City of Plymouth Planning Commission

Regular Meeting Agenda

**Final Planned Unit Development
For
City of Plymouth, Michigan**

Applicant:	Donofrio Wil Cox, LLC 1156 Beech St. Plymouth, MI 48170
Project Name:	Wilcox Mill Restoration PUD
Plan Date:	Engineering Plans: January 8, 2024
Latest Revision:	Engineering Plans: January 16, 2025 Landscape Plan: January 21, 2025
Location:	230 Wilcox Road, Plymouth, MI
Zoning:	R-1, Single-Family Residential District
Action Requested:	Preliminary PUD Approval

PHOTOMETRIC PLAN PLAN
FOR: DONOFRIO WIL COX, LLC
ALL OF LOT 508 AND PART OF LOTS 506 AND 507,
"ASSESSORS PLYMOUTH PLAT NO 16", CITY OF
PLYMOUTH, COUNTY OF WAYNE, STATE OF MICHIGAN,
AS RECORDED IN L. 66, P. 82 OF PLATS W.C.R.

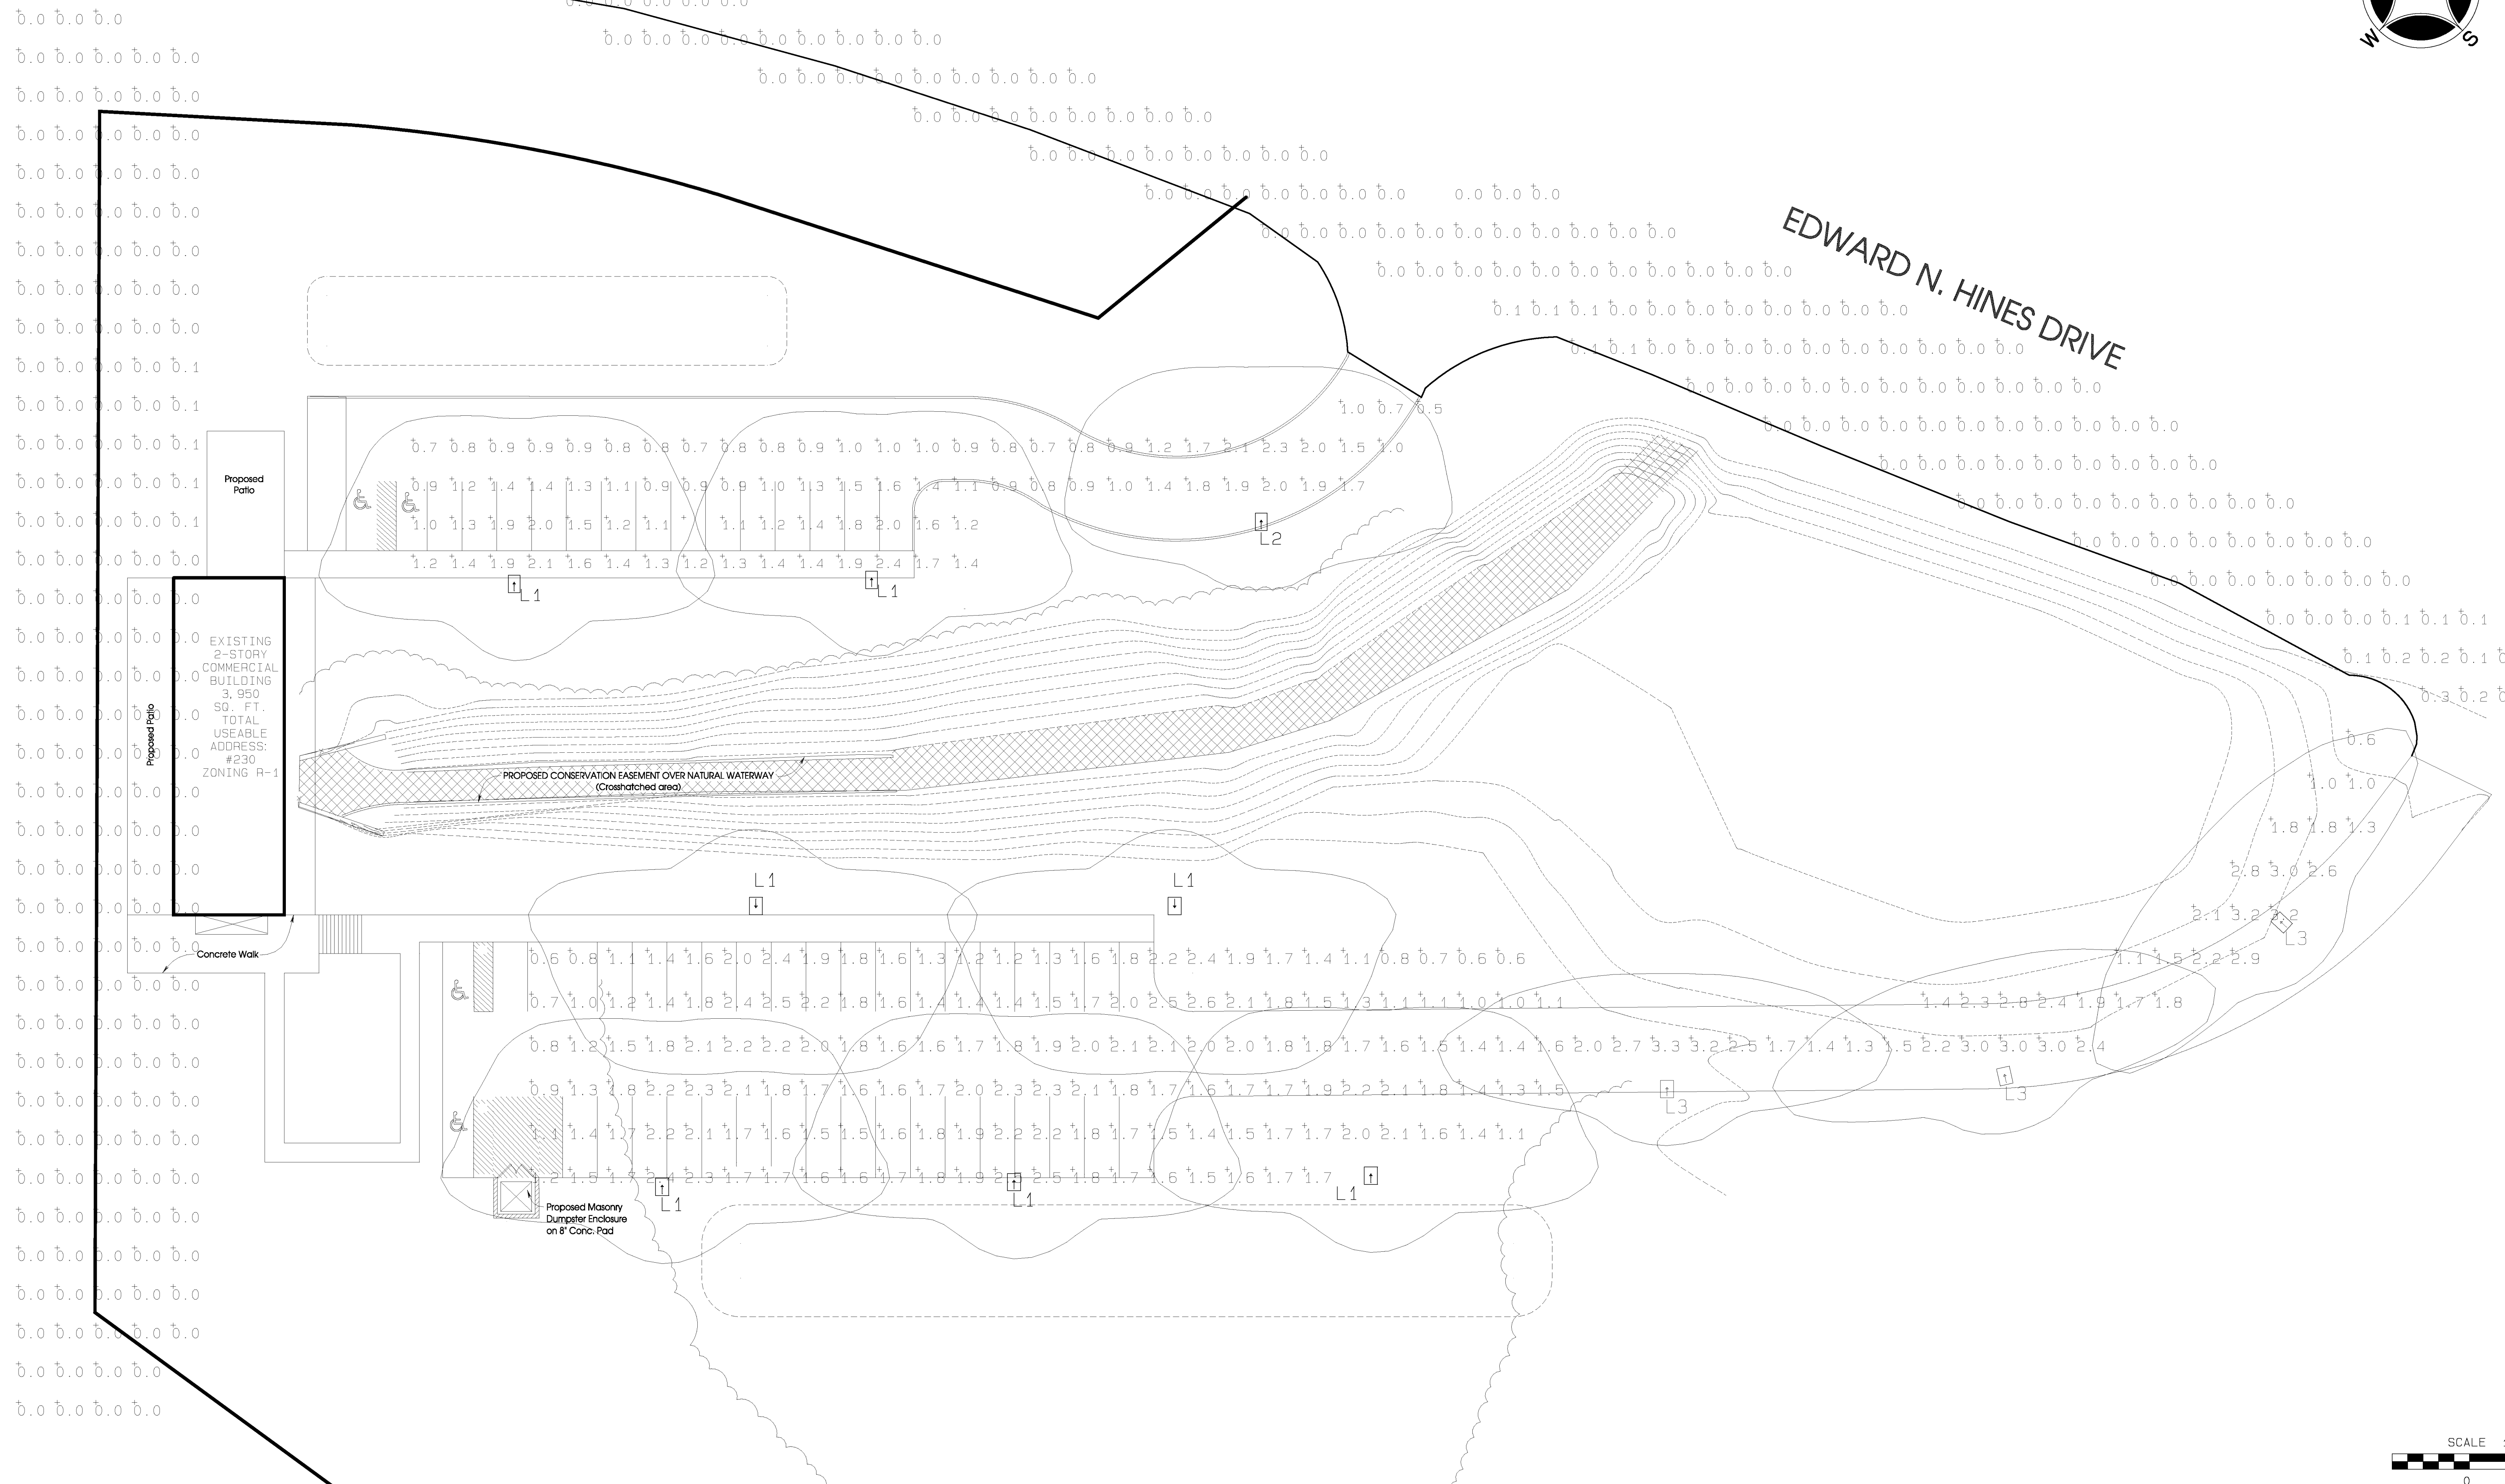
The ordinance limits lighting levels along property lines shared with residential uses to 0.1 footcandles, and 0.3 along property lines shared with non-residential uses. The property lines shared with residential uses are not shown on the plans, but the large open space, and intervening slopes and vegetation, between the parking lot lights and the nearest neighbor should ensure that the light levels meet the requirement. The minimum lighting levels in the parking lots are also met.

No information about the proposed site fixtures has been provided. Manufacturer cut sheets of the proposed fixtures should be provided to confirm that the fixtures are downward-facing and can accept a house-side shield if needed. Also, the maximum height of the pole-mounted fixtures needs to be shown on the plans, including the base in the height dimension. Pole-mounted fixtures cannot exceed 25-feet or the height of the building, whichever is shorter.

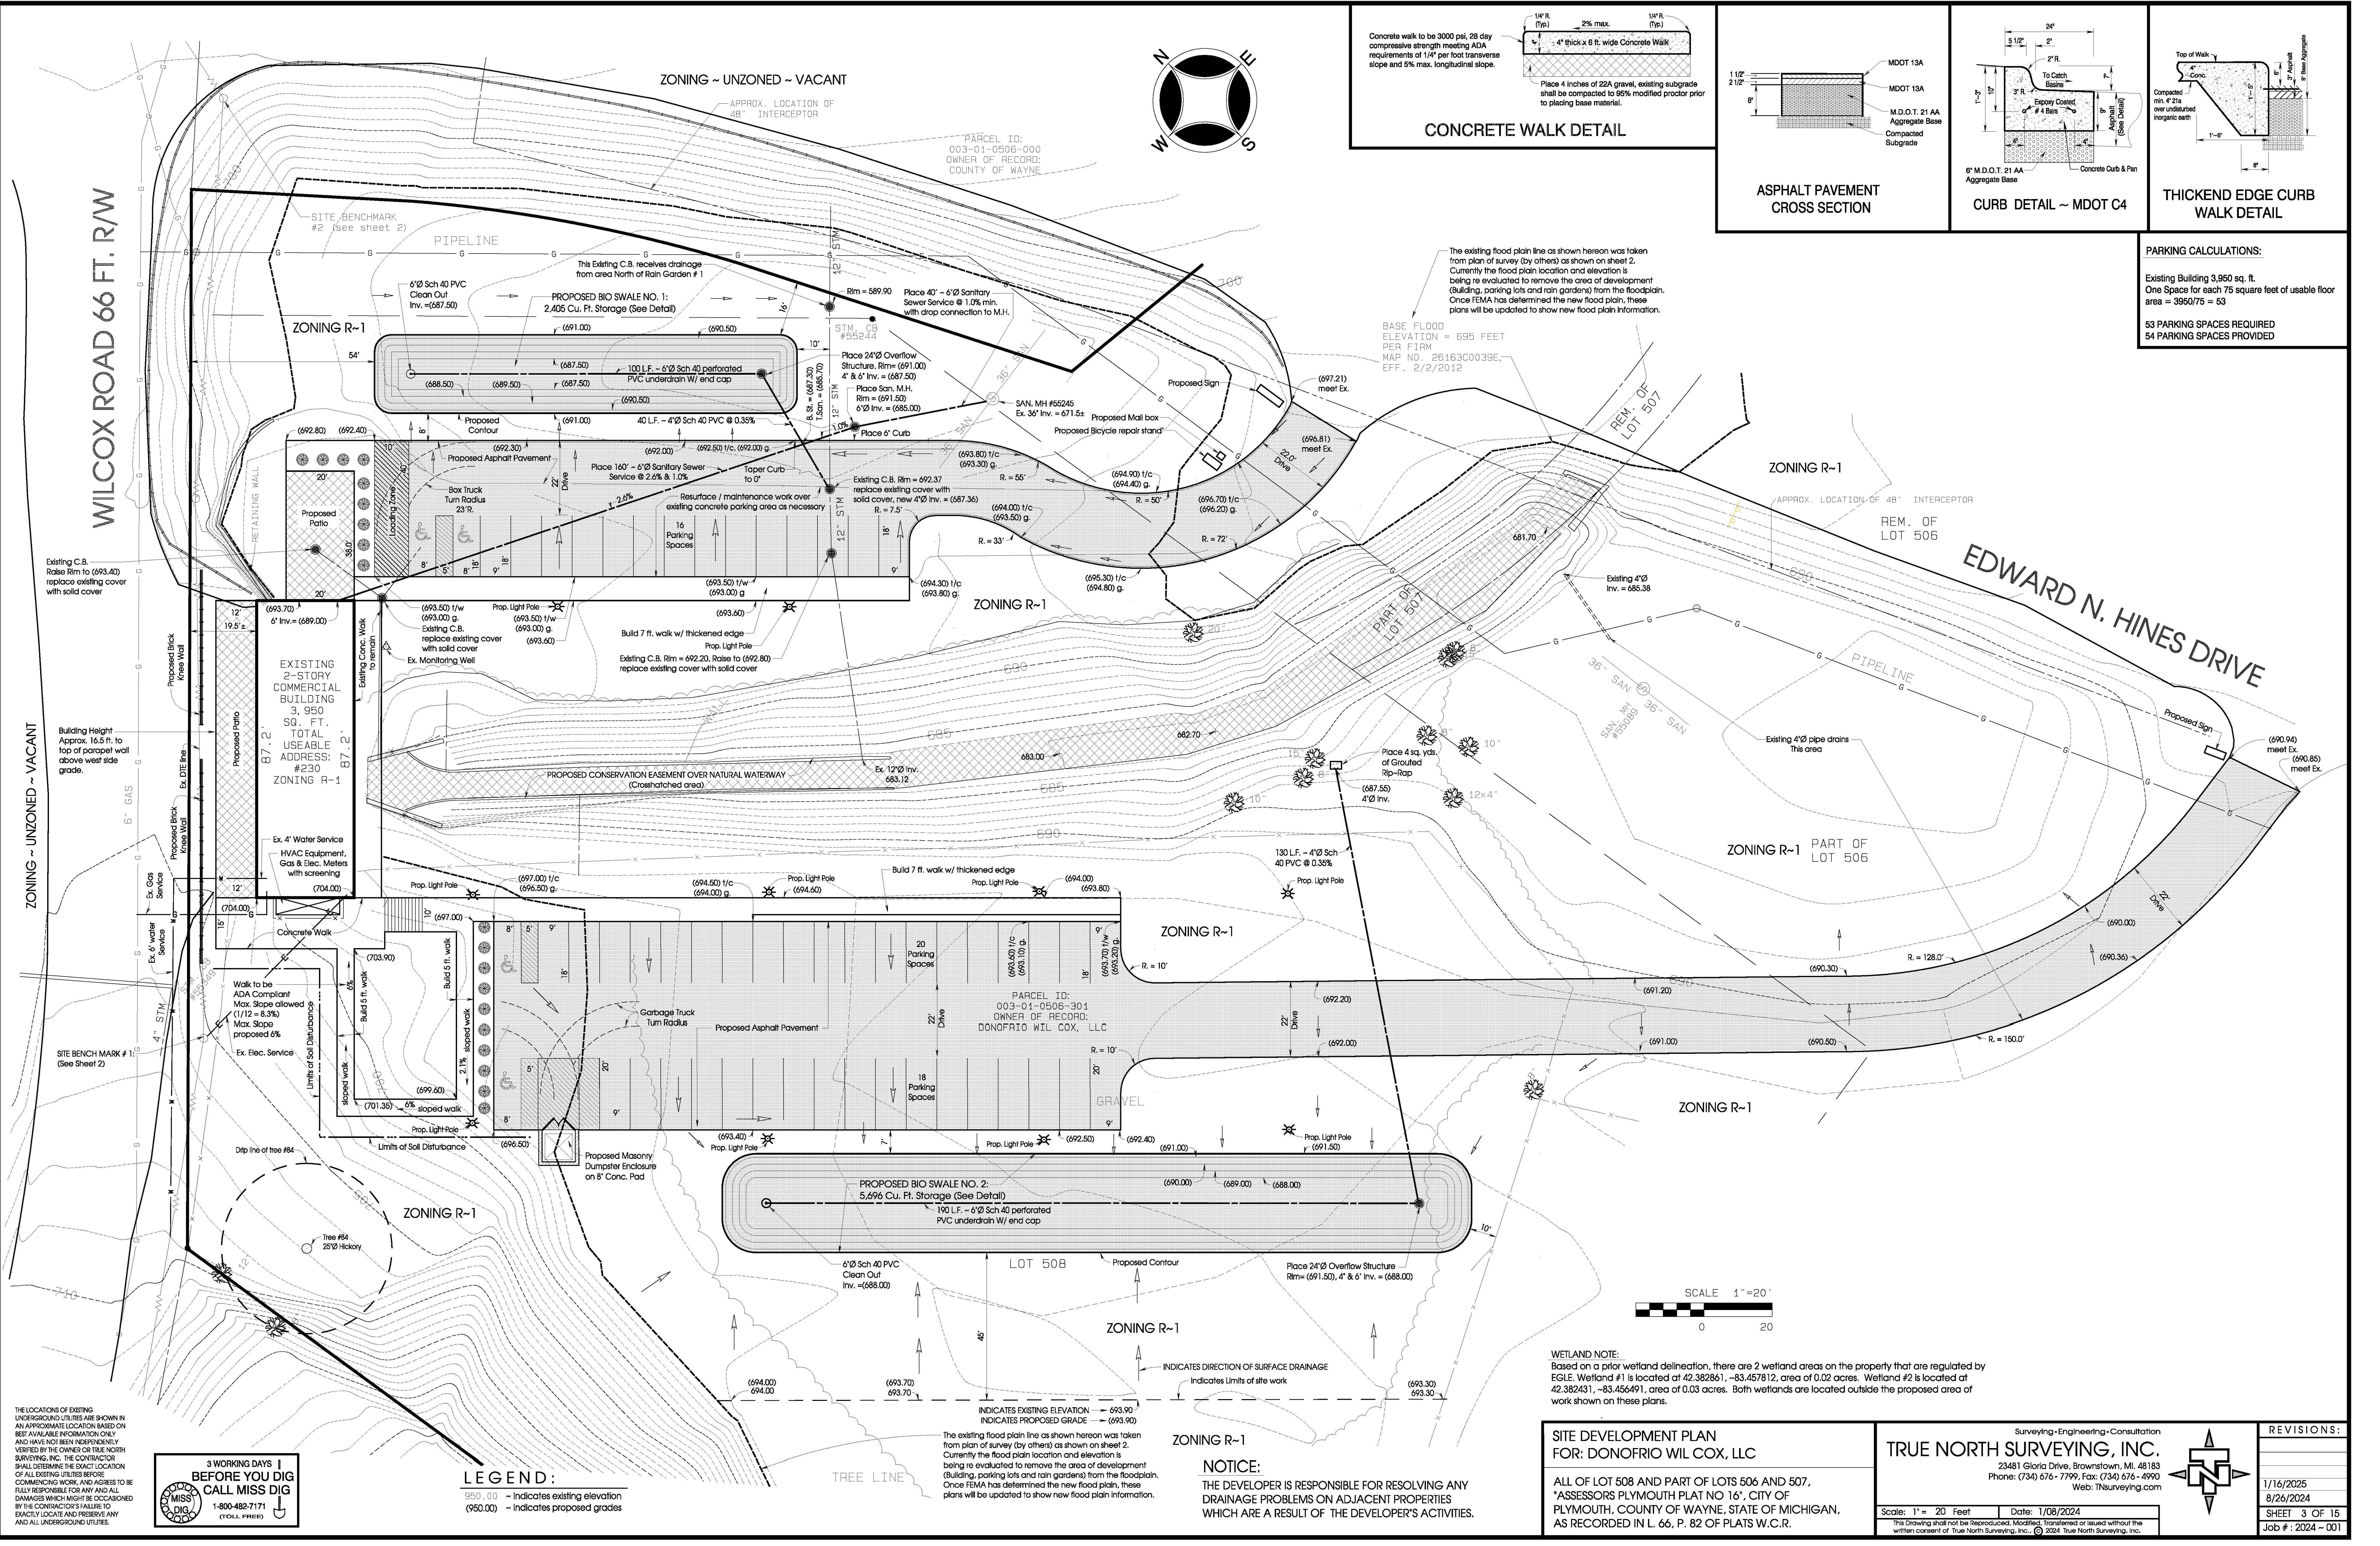
The proposed landscape plan shows “meadow lawn” along Hines Drive, which would not provide the required screen. The applicant explains that they don’t want trees blocking the view of the building from the street. A line of shrubs along the edge of the parking lot will accomplish both goals, screening the parking lot from the street while providing drivers with a view of the building. Several shrub species, such as Viburnum, Chokeberry, or Dogwood, listed on the Storm Sewer Profile and Detail Sheet under the heading “Bioswale Recommended Planting List” could be used to accomplish the required screen.

The plans show a 10' x 40' loading/unloading space in the easterly lot next to the building. The ordinance requires a 10' x 50' loading space for a building of this size. As requested, the anticipated delivery trucks will be small Box Trucks or Delivery Vans. With this size delivery vehicle, we would consider the proposed loading/unloading zone sufficient. The turning movements of the proposed delivery trucks is now shown on the plans, clarifying that a delivery truck can successfully use the loading/unloading zone as proposed. This information has also been provided for a trash hauler accessing the dumpster screen in the westerly parking lot.

Neither parking lot has any interior landscape islands. One tree is provided at the perimeter of the easterly parking lot. The required parking lot islands and trees need to be added to the plans.

Items to be Addressed: 1) *The number of parking spaces will accommodate sit-down restaurants or a bar; The Planning Commission should determine if a sit-down restaurant or bar at this location supports the “park” character of the area, is likely non-disturbing to residential neighbors, and is consistent with the Master Plan.* 2) *Use shrub species such as Viburnum, Chokeberry, or Dogwood, listed on the Storm Sewer Profile and Detail Sheet under the heading “Bioswale Recommended Planting List” to accomplish the required parking lot screen.*
